**SUNDRY NOTICES AND REPORTS ON WELLS**  
*Do not use this form for proposals to drill or to re-enter an abandoned well. Use Form 3160-3 (APD) for such proposals.*

*3 Timmy*

Re: Permanent Abandonment

CONDITIONS OF APPROVAL

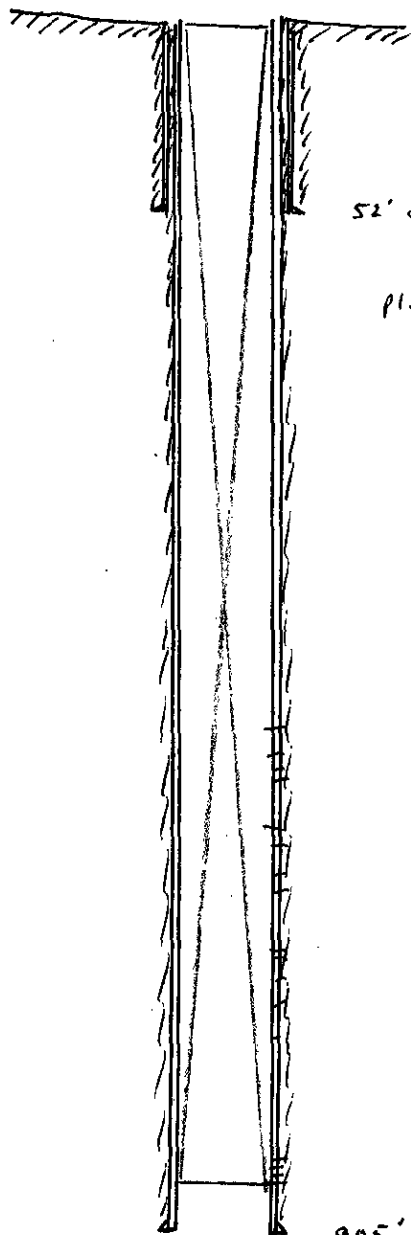
1. Plugging operations authorized are subject to the attached "General Requirements for Permanent Abandonment of Wells on Federal and Indian Lease."
2. Farmington Office is to be notified at least 24 hours before the plugging operations commence (505) 599-8907.
3. The following modifications to your plugging program are to be made:
  - a) After plug has set, tag top of cement and refill casing with cement if necessary.
